NAVY ELECTRONICS LAB SAN DIEGO CALIF
EVALUATION OF BATHYTHERMOGRAPH MODELS OC-1C/S AND OC-2C/S.(U)
JAN 58 J E ROBERSON
NEL-827

EVALUATION OF BATHYTHERMOGRAPH MODELS OC-1C/S AND OC-2C/S.

U. S. NAVY ELECTRONICS LABORATORY, SAN DIEGO, CALIFORNIA
A BUREAU OF SHIPS LABORATORY

Evaluate preproduction samples of surface-vessel bathythermograph models OC-1C/S and OC-2C/S for compliance with specifications.

FIGURE 7

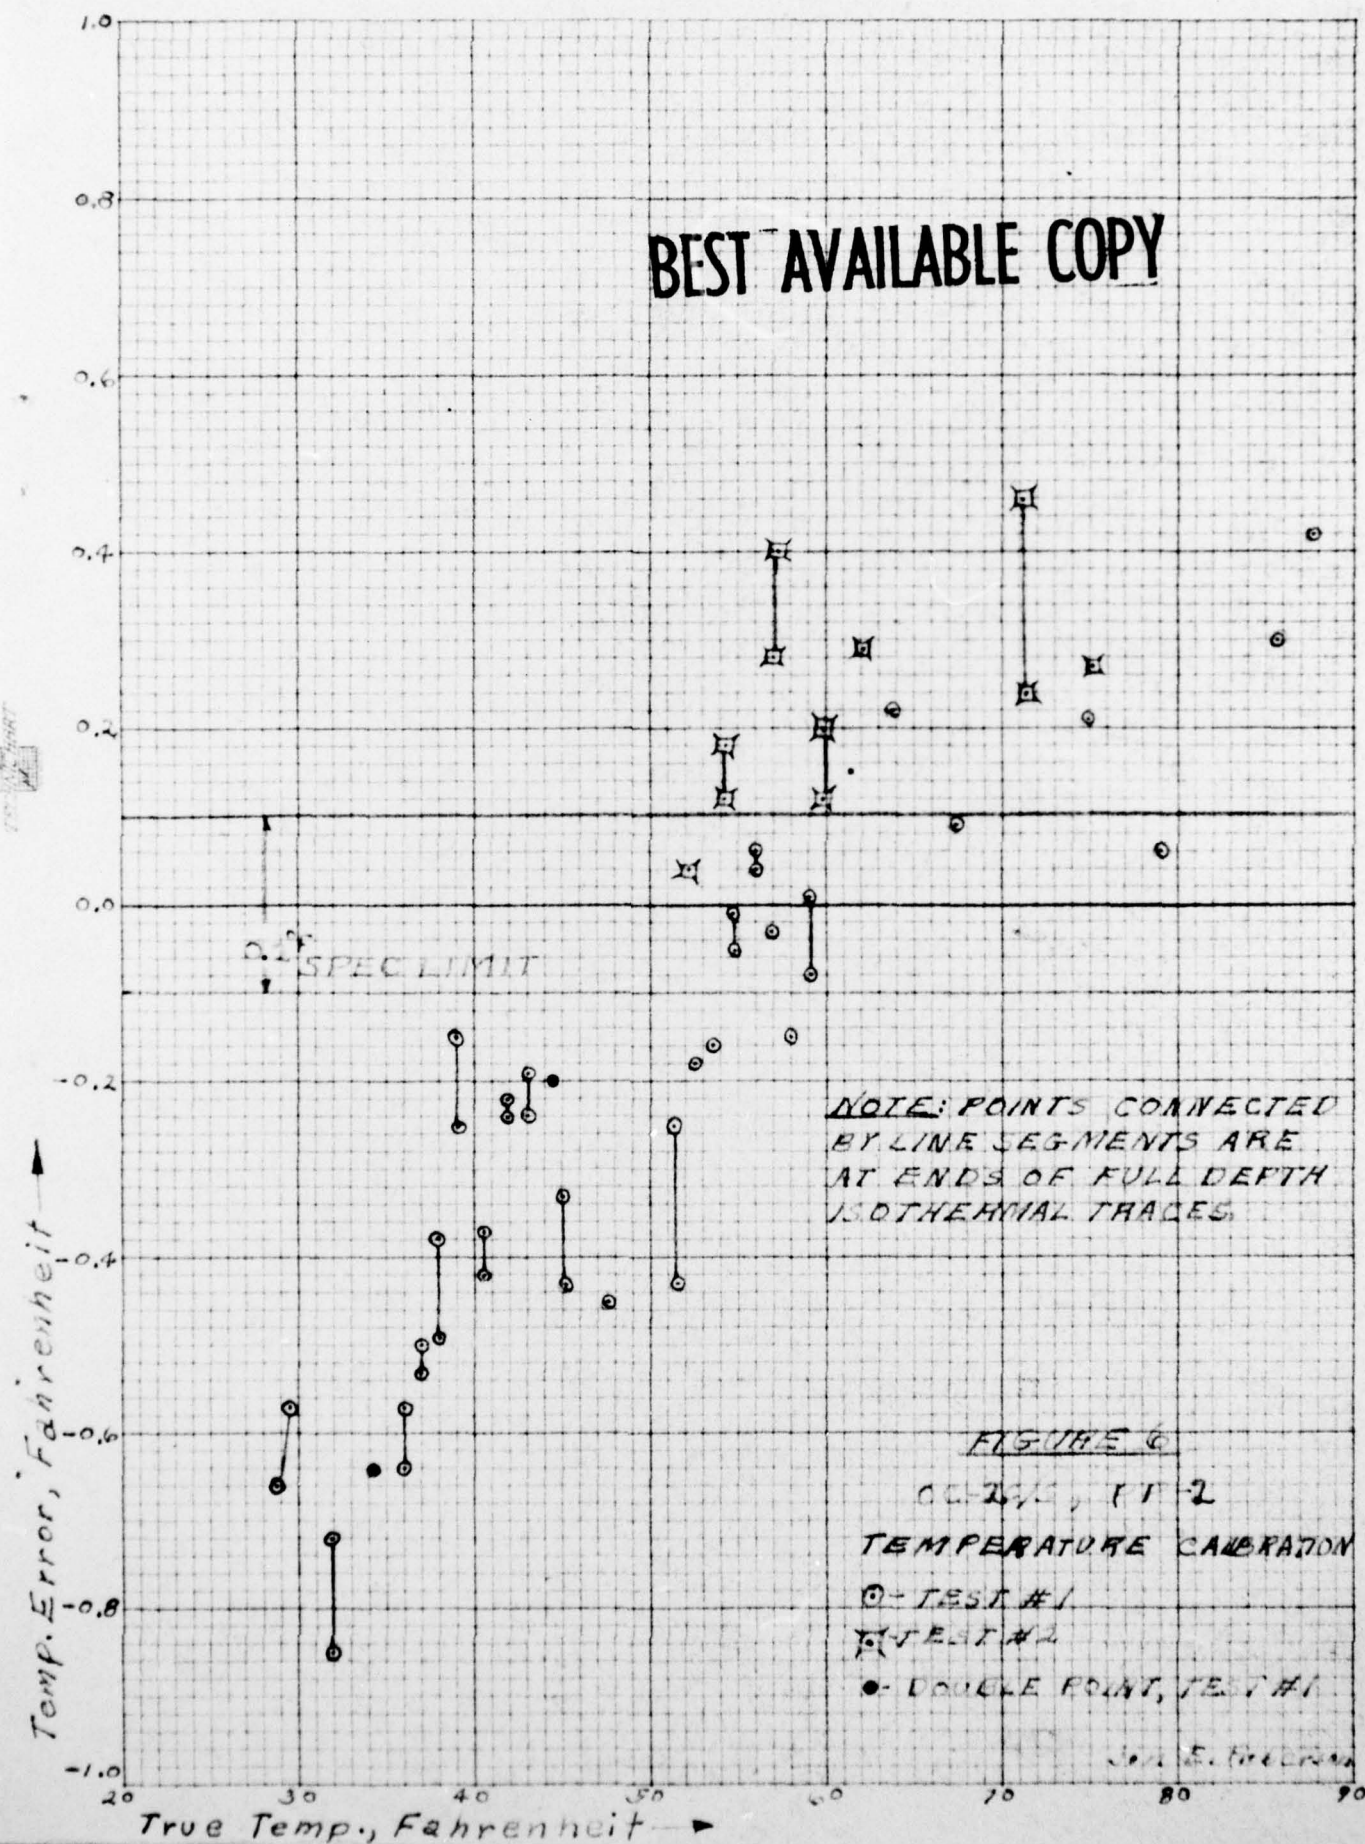
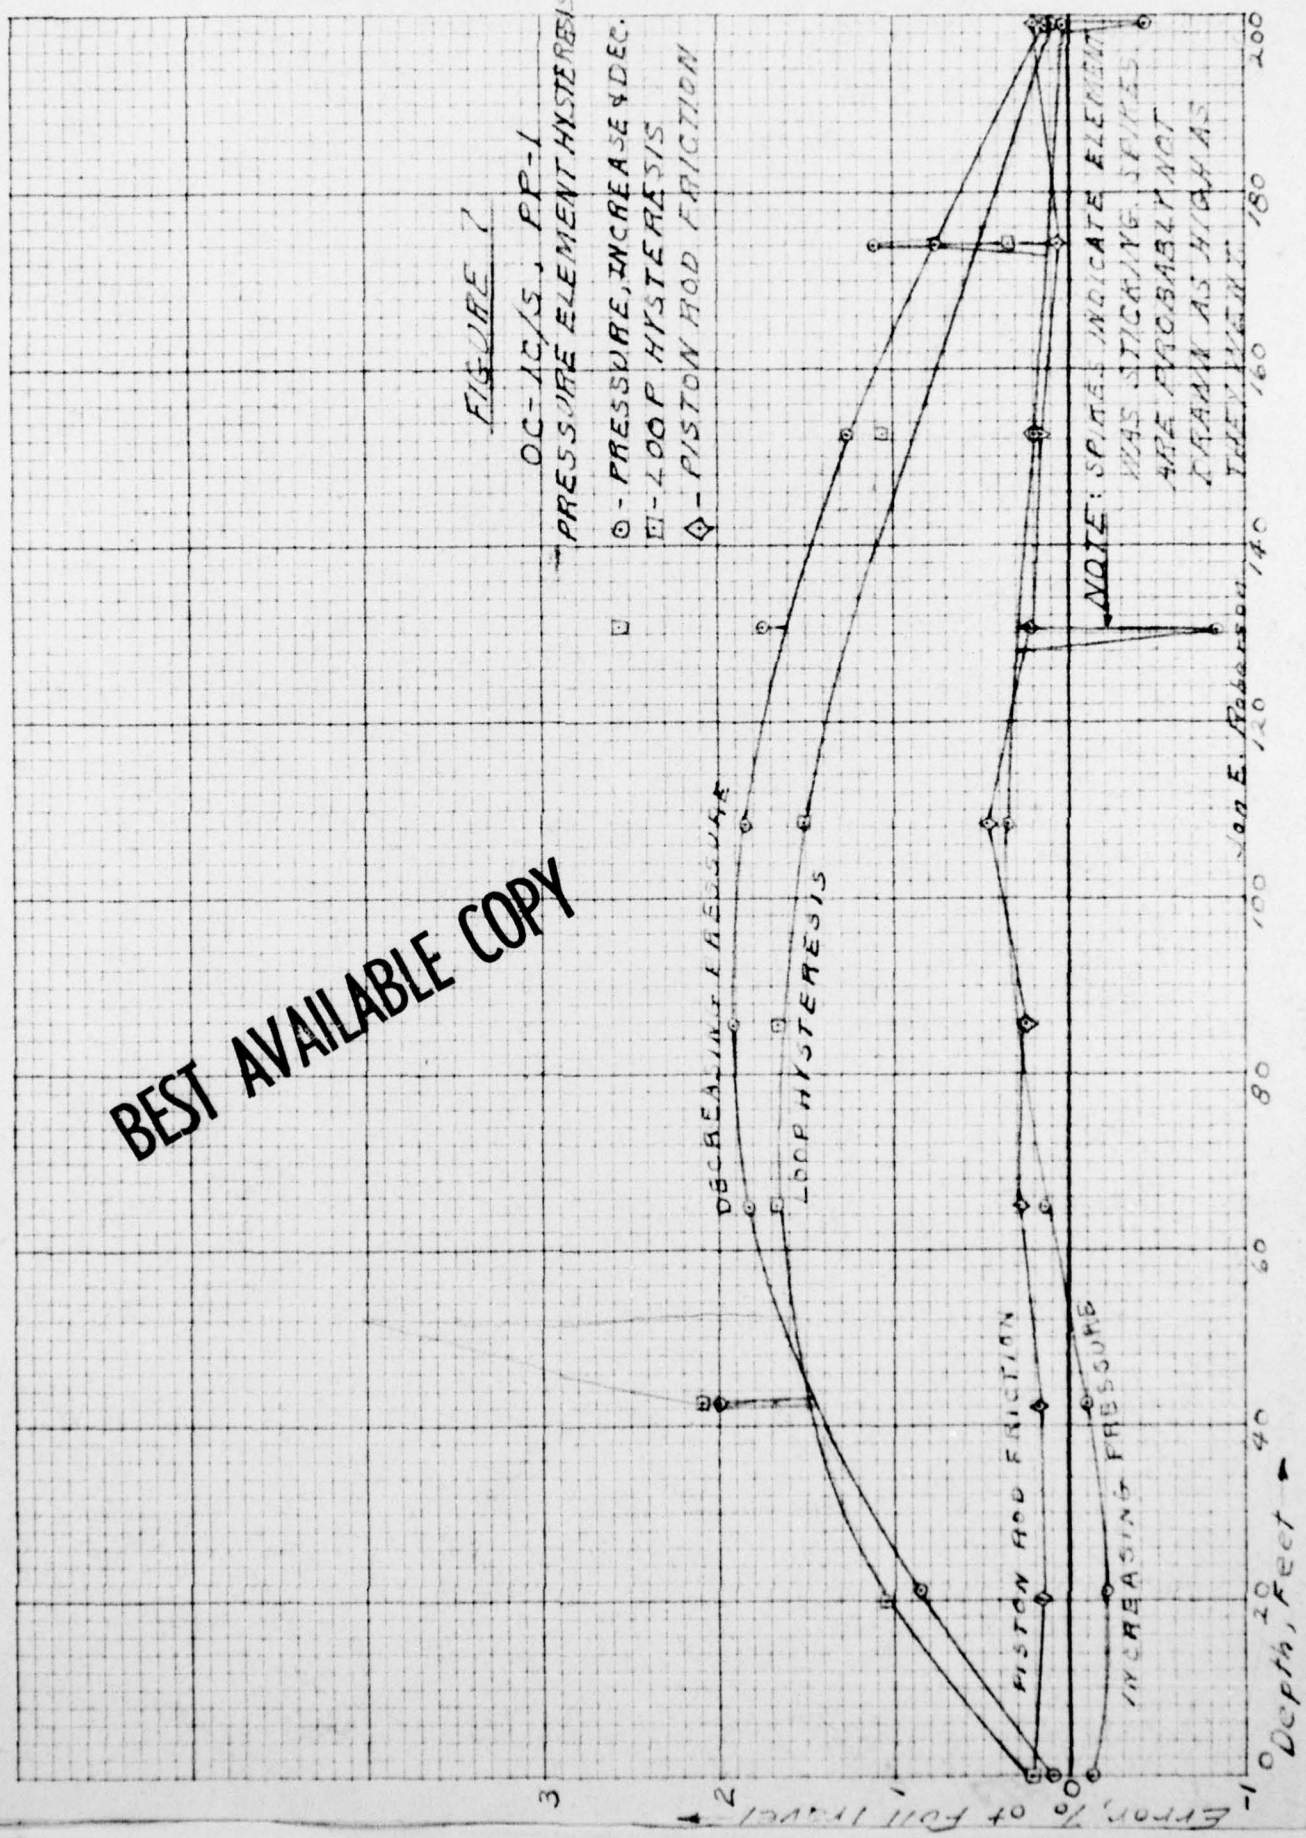
Figure 7 shows the loop plots, which give the departures of the data from a straight line fit. The curves of increasing and decreasing pressure show four points where the element appears to have jammed. The element was also seen to jump about 0.01 inch (1.5 per cent of full travel) on two occasions during the test between 10- and 40-foot depths. A jump of 0.01 inch corresponds to a 2.6-pound breakaway

force. A later examination showed that the spiral groove on the piston rod would catch on the edges of the bushings if a small lateral force was exerted, such as might be expected from a slight eccentricity of the spring. (It is almost impossible to make the spring force concentric with the piston rod.) The snagging of the groove might have caused the peaks of the curves. If the peaks are ignored, the loop hysteresis assumes a regular shape with a maximum of 1.3 per cent. The loop hysteresis is excessive.

The curves in figure 7 show that the hysteresis and compliance variation opposed each other during the trace of increasing depth, causing it to be quite straight (within 0.6 per cent and better) and the trace of decreasing depth to be noticeably curved (within 1.3 per cent). Therefore, readings of either increasing depth or of an average of increasing and decreasing depths will best meet the 1 per cent requirement.

3. Eliminate the abnormal piston rod friction found in the hysteresis tests. This can be done by increasing the pitch of the spiral groove or eliminating the groove, and rounding the bushing edges.

6. Reduce the nonlinearity of the pressure elements to 1 per cent or less on the traces of decreasing depth, and reduce the loop hysteresis to 1 per cent or less.

FIGURE 2
OC-20/5, PP-2
PRESSURE ELEMENT HYSTERESIS
O - PRESSURE, INCREASE & DEC
H - LOOP HYSTERESIS

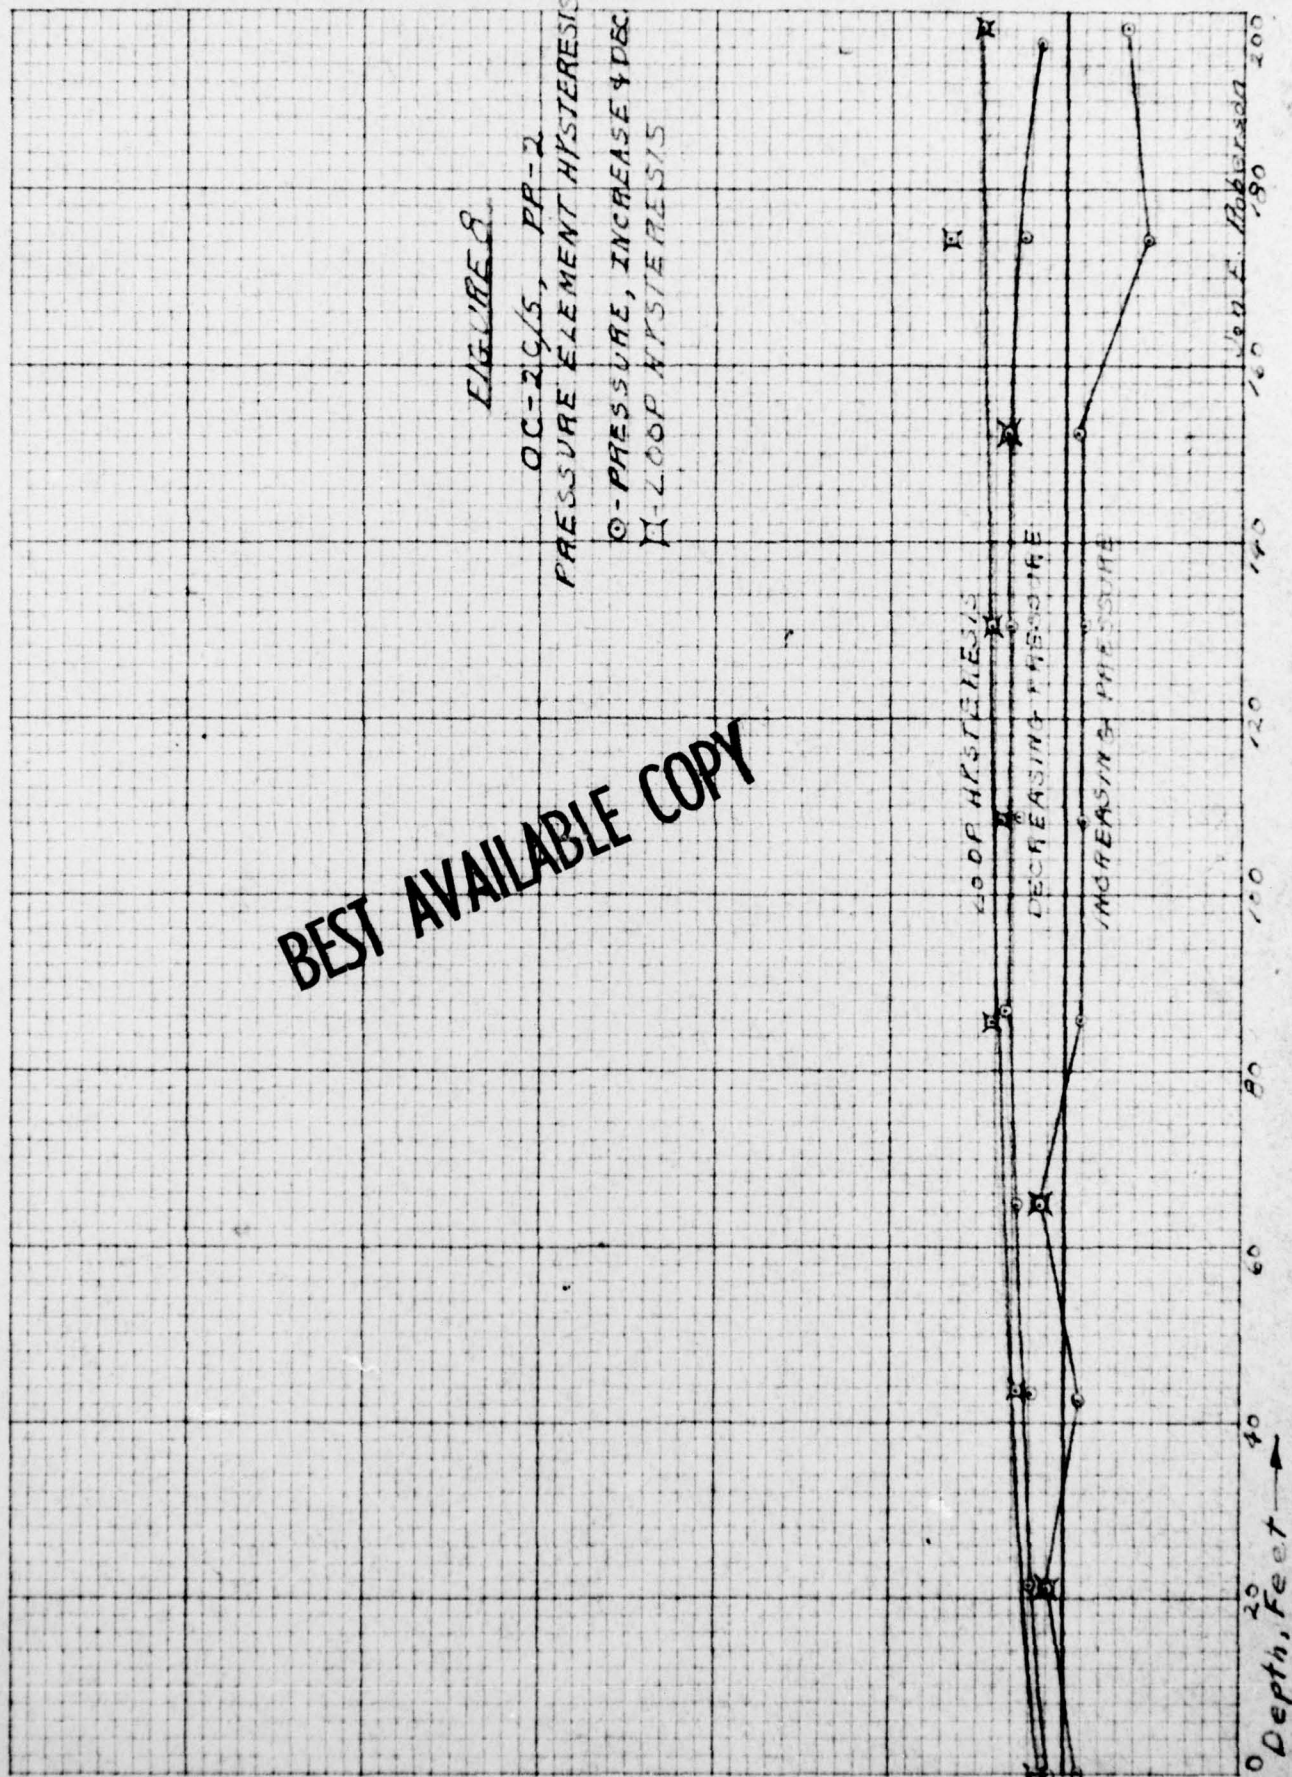
A full-depth loop test was made on the element, but the readings extended to only 44 per cent of full depth, which was the limit of the manometer. The curves appear in figure 8 and are similar to figure 7. The point friction was not measured. The maximum loop hysteresis is about 0.50 per cent. Abnormal friction shows only on the curve of increasing depth and is about 0.3 per cent. The element was not seen to jump during the test.

The PP-1 element has more abnormal piston friction and hysteresis than the PP-2 element because the stiffer spring of the latter overrides the defects. If the ordinate of figure 8 is multiplied by 450/200 to correct for the spring, the values for PP-2 are still somewhat less than those for PP-1. The results indicate that most of the loop hysteresis is in the bellows.

Figure 9. PP-1 Bellows crack.

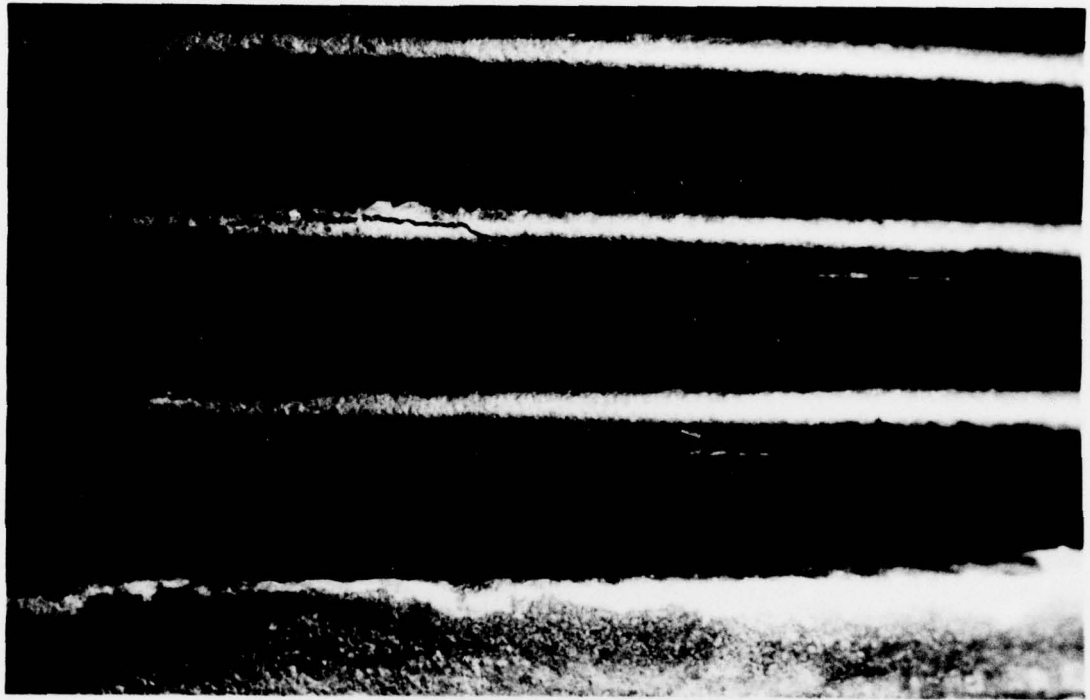
The specification requires the elements to withstand 100 full depth pressure cycles and 125 per cent of full depth pressure without permanent deflection or other damage. The PP-1 sample was accidentally dropped to 200 per cent of full depth pressure during the sea trials. The excessive pressure did not cause failure at the time. During the life test the bellows cracked at the 23rd cycle, and the element filled with water. The element had received about 35 cycles in previous tests, giving 60 cycles at failure in addition to those received at the factory. The test was continued to the 43rd cycle to make the cracks more obvious. The cracks found were on the second and sixth outer folds from the base, as shown in figure 9.

The accelerated life and overpressure tests disclosed cracks on the outer folds of the bellows nearest the bases of the elements. The outer folds have a much sharper bend radius than the inner ones and therefore fail first. The rough and grainy appearance of the outer folds shows that the metal has been excessively deformed and is metallurgically unsatisfactory. The bellows appear to have been hydraulically formed, resulting in crimped outer folds. The base bellows might have failed because they were heat treated more severely than the others during soldering of the base.

5. Study and eliminate the causes of bellows failure.
